HISTORIC AND DESIGN REVIEW COMMISSION

HDRC CASE NO: 2018-443
ADDRESS: 108 N MEDINA
LEGAL DESCRIPTION: NCB 264 BLK 76 N 69.05 FT OF S 133.45 FT OF 9 ARB A9
ZONING: D, HE
CITY COUNCIL DIST.: 5
DISTRICT: Cattleman Square Historic District
LANDMARK: I&GN Depot Cluster
APPLICANT: John Speegle/SKDA
OWNER: North Medina LLC
TYPE OF WORK: Construction of an elevator and stair tower, rehabilitation
APPLICATION RECEIVED: August 31, 2018
60-DAY REVIEW: October 20, 2018
REQUEST:

Applicant's Project: Santa Monica Hotel Elevator & Stairs Addition FINAL APPROVAL

A-5.0.01 GUARDRAIL ELEVATIONS & SECTIONS
SCALE: 1/4" = 1'-0"

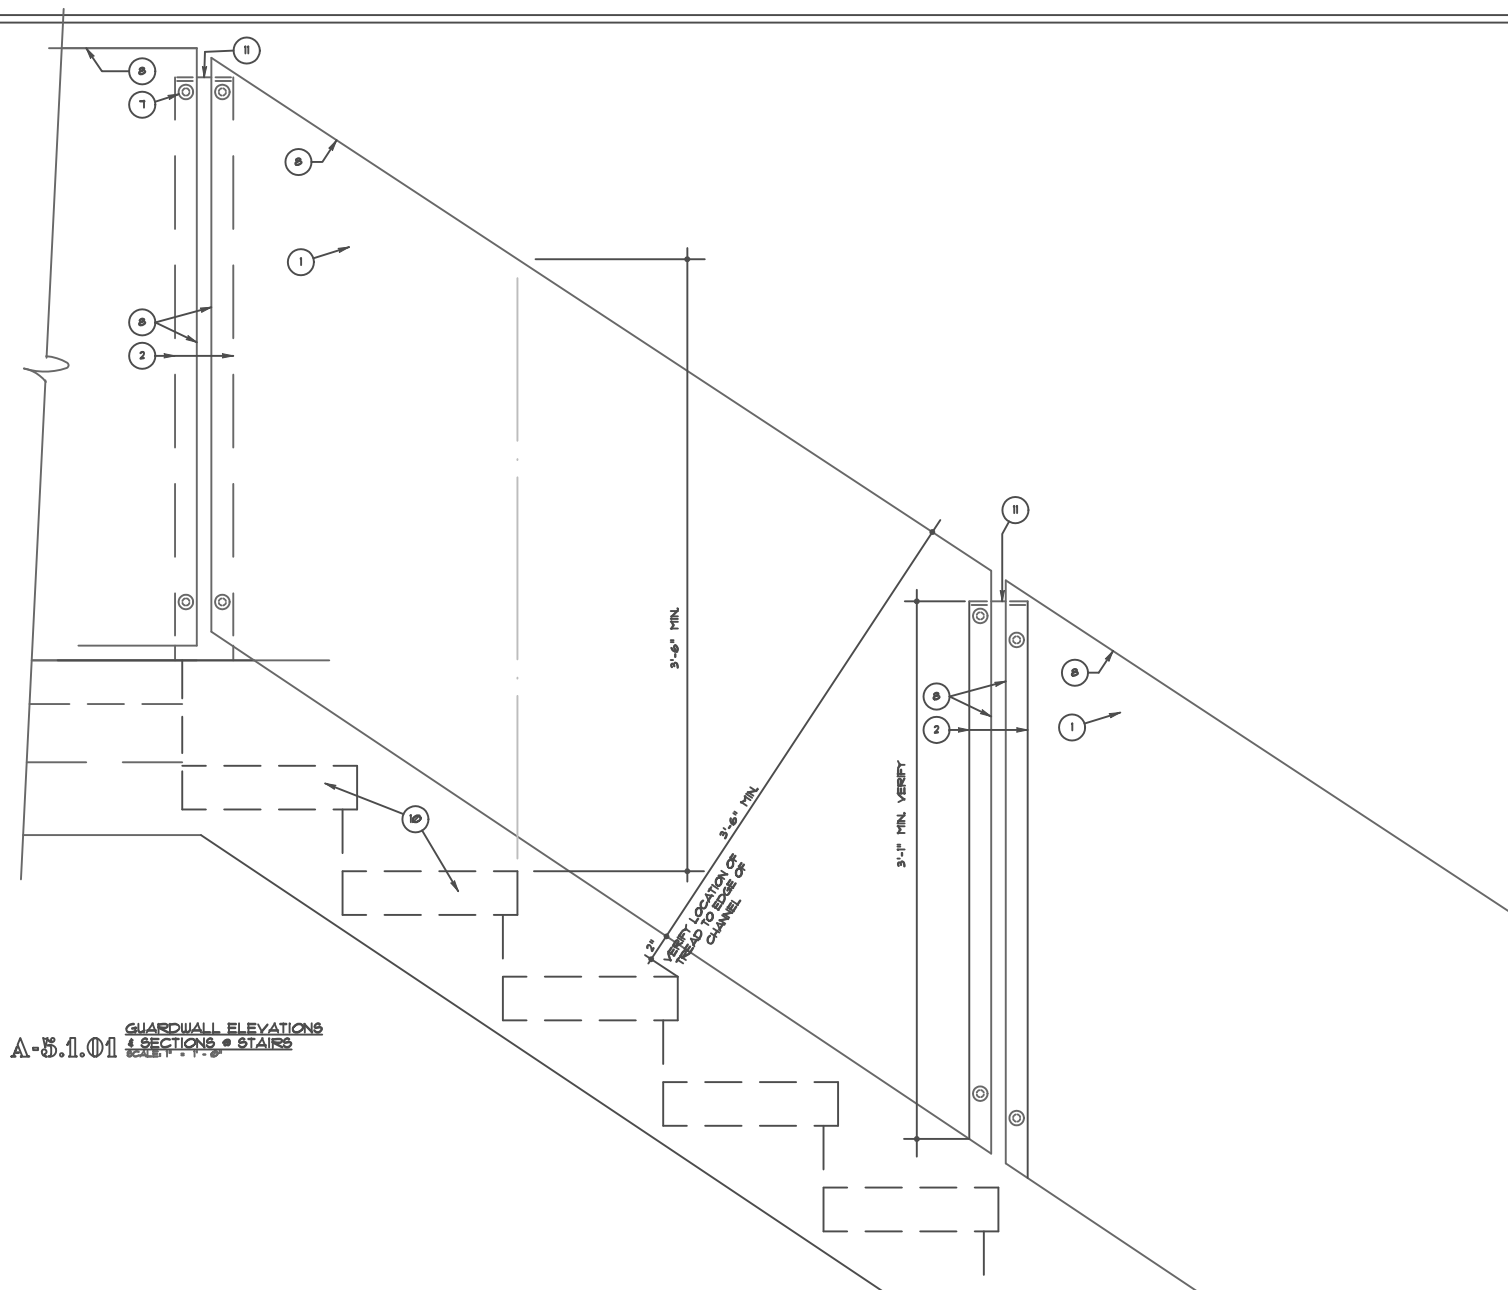
- ii. That when submitting for final approval the applicant submit details that include balcony details, egress door elevations, tempered glass handrail details and additional information regarding materials including a material sheet.

- g. **BALCONIES** – In addition to the proposed elevator and stair tower addition, the applicant has proposed to construct balconies at each level on the rear façade to feature tempered glass handrails. The balconies will provide a secondary means of egress. Generally, staff finds the proposed balconies to be appropriate. Historically, commercial brick structures such as this would have featured a rear balcony. The applicant has noted the installation of egress doors in existing, rear window openings. The existing openings are currently door opening and per the construction documents, the original opening size will be preserved.

Balcony Details: we have attached drawing sheet of the glass and metal handrails which illustrate a clear glass tempered guardrail panel, with a finished top elevation of 42" above the adjacent finish floor, as per building code. The balcony structure will be a raw steel finish to oxidize similar to the Corten (weathering steel) metal siding, installed below it.
